DEVELOPMENT ASSESSMENT REPORT	
<b>Application No.</b>	DA/2022/0034
<b>Address</b>	9 Westbourne Street STANMORE NSW 2048
<b>Proposal</b>	Demolition of existing building. Torrens Title Subdivision of existing lot into 2 lots. Construction of a semi-detached dwelling with a garage and studio above at rear to each lot. Landscaping and associated works.
<b>Date of Lodgement</b>	1 February 2022
<b>Applicant</b>	Monument Plan Pty Ltd
<b>Owner</b>	Ms Maria L Saraceno Mr Andrea Vedovato
<b>Number of Submissions</b>	12
<b>Value of works</b>	\$915,000.00
<b>Reason for determination at Planning Panel</b>	Number of submissions
<b>Main Issues</b>	Solar access and overshadowing; building massing and setbacks; façade design and streetscape; submissions
<b>Recommendation</b>	Deferred Commencement Approval
<b>Attachment A</b>	Recommended conditions of consent
<b>Attachment B</b>	Plans of proposed development

This report is an assessment of the application submitted to Council for the demolition of the existing building, Torrens title subdivision of the existing lot into two (2) lots, and construction of a semi-detached dwelling with a garage and studio above at the rear to each lot including landsc

Figure 1: Ground floor plan of proposed development showing location of principal living area and principal area of private open space.

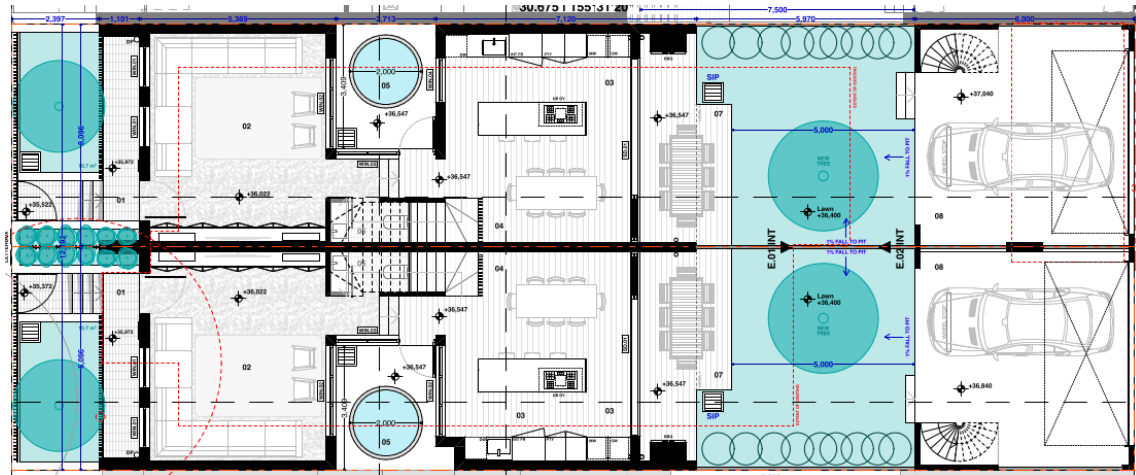
western orientation. A secondary living area comprising the kitchen and dining room are provided adjacent to the POS area at the rear of the dwelling (see Fig. 1 below).

The windows of the principal living area of each dwelling will receive a minimum of 2 hours of direct solar access between 9.00am-3.00pm during midwinter.

Figure 4: Floor plan of proposed first floor (centre), approved development at no. 7 Westbourne Street (top), and existing development at no. 11 Westbourne Street (bottom).

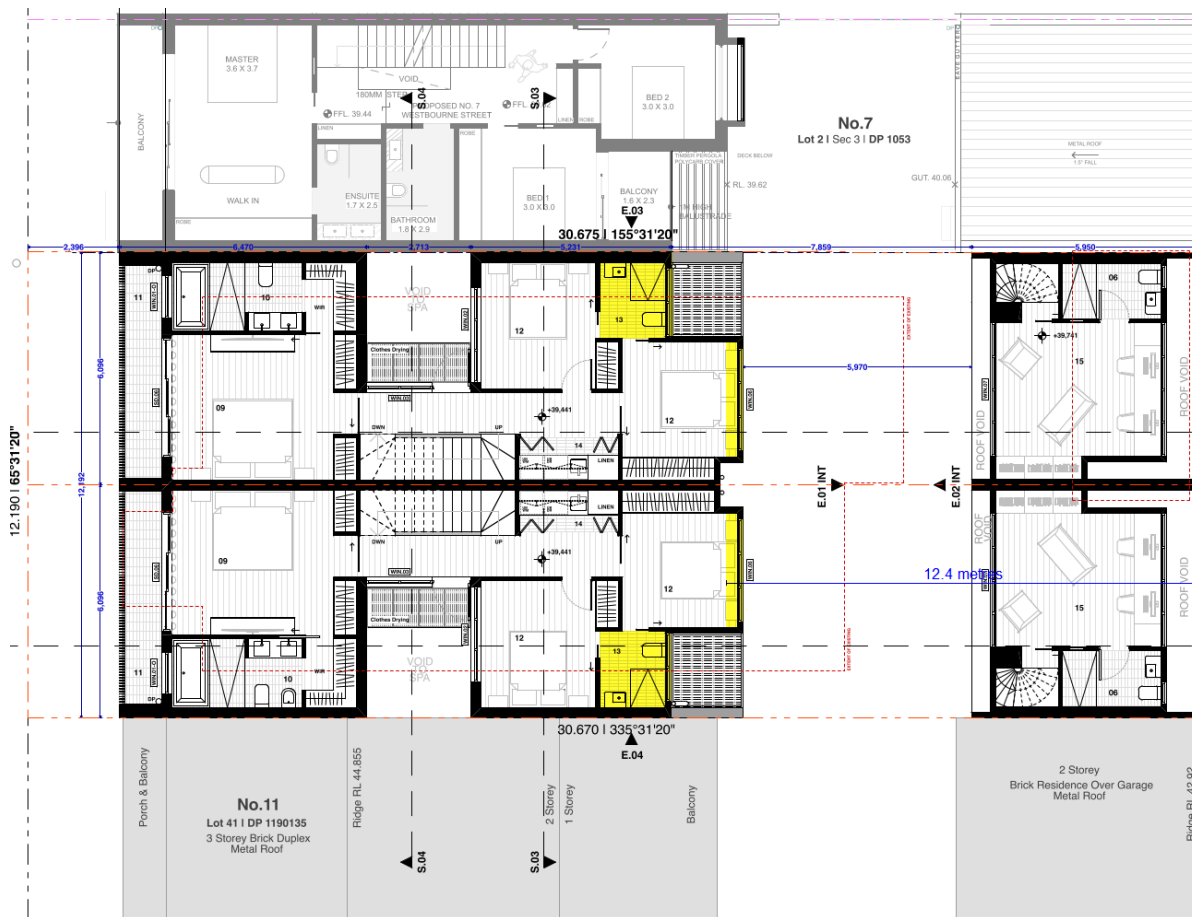
- The southern rear wall of the first floor rear bedroom is to be setback a minimum of 12.4m from the rear boundary so as to align with the setback of the adjoining dwelling at 7 Westbourne Street and not protrude beyond 11 Westbourne Street.
- The first floor rear bathroom of each dwelling is to be deleted.
- The southern rear wall of the second floor of each dwelling is to be setback a minimum of 15.5m from the rear boundary.
- The eastern and western elevation walls of the second floor bedroom are to be setback 1.5metres from their respective side boundary.

Project Description		Client	
	9 WESTBOURNE STREET STAMORE TORRENS TITLE SUBDIVISION AND LOT 3 DP 135288		MFT+ TCEN	
	Project		Drawing Name	
	FIRST FLOOR		GM	
	Scale		Drawing No	
	1:100 @ A3		2114	
	Title		Revision	
	MAY 22 DA.07		2

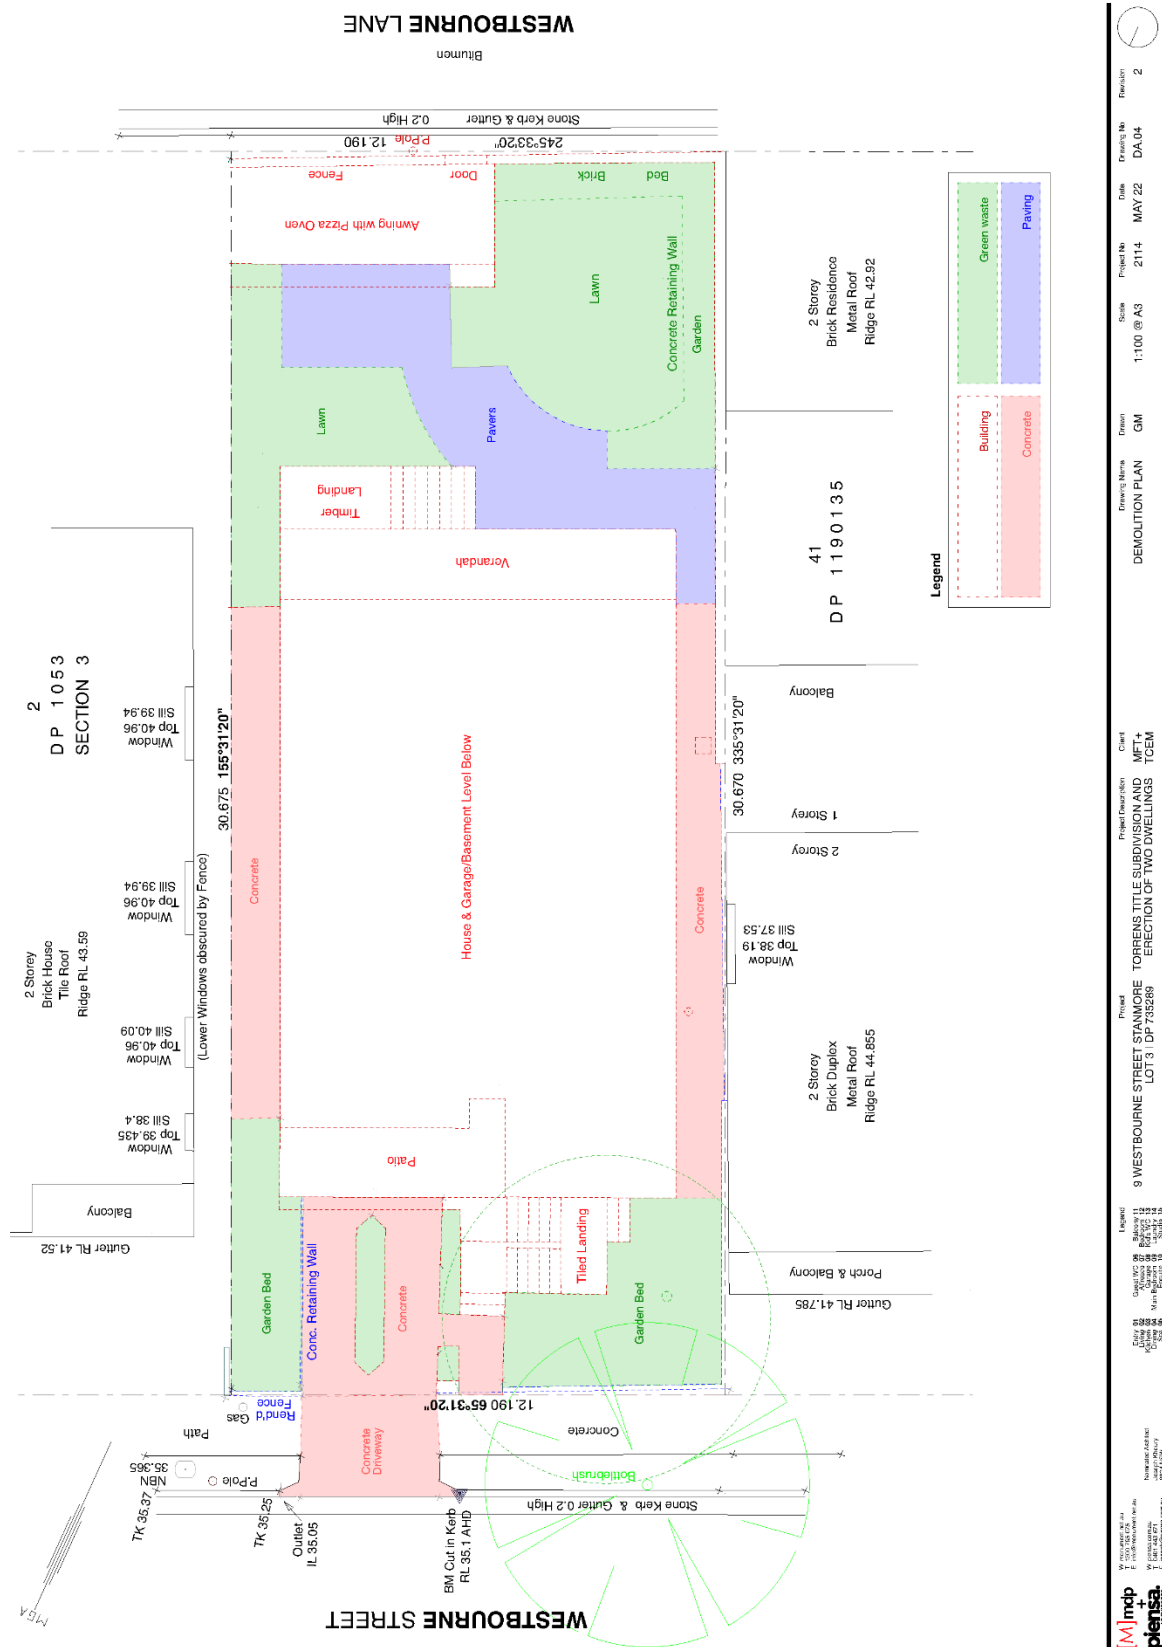
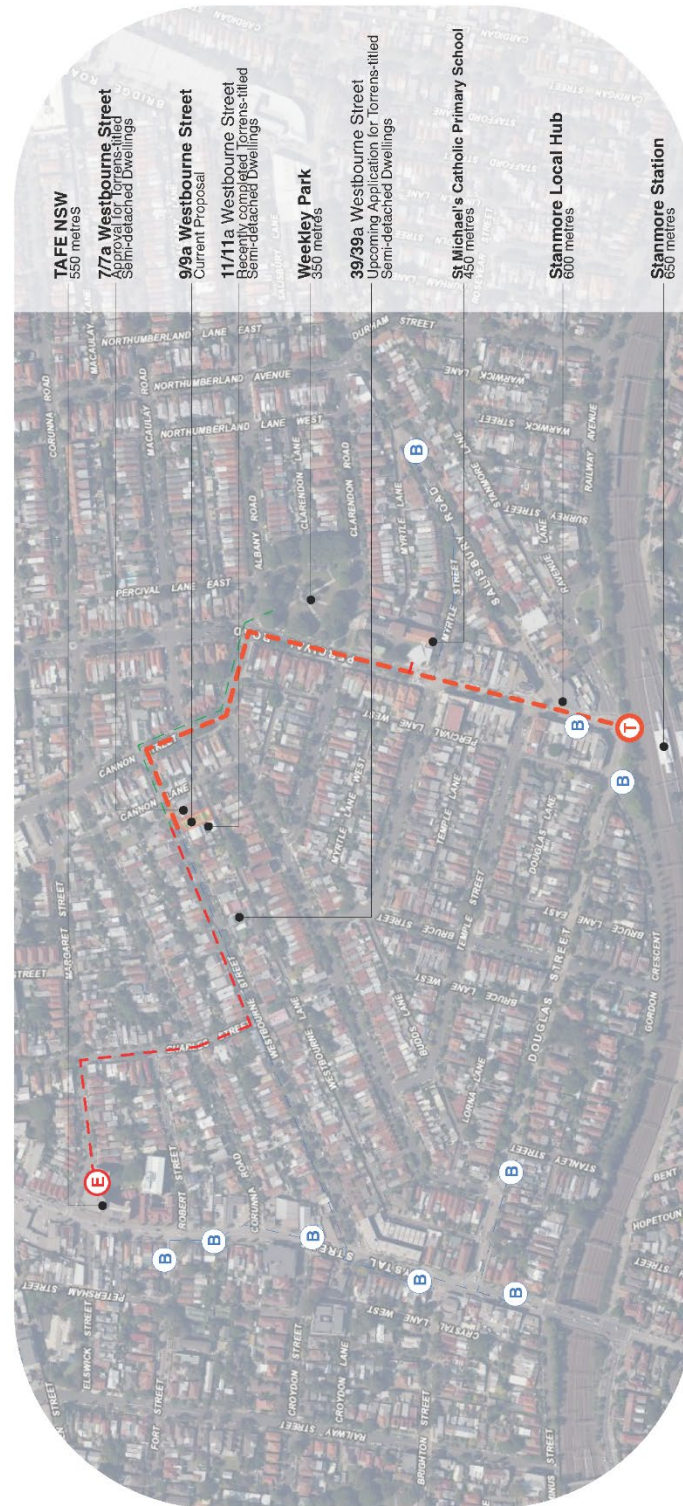
- a. The southern rear wall of the first floor rear bedroom of each dwelling labelled '12' on plan number 2114 DA.07 Rev 2 prepared by Piensa Architects and dated May 2022 must be setback a minimum of 12.4m from the rear boundary.

- b. The first floor rear bathroom of each dwelling labelled '13' on plan number 2114 DA.07 Rev 2 prepared by Piensa Architects and dated May 2022 must be deleted.
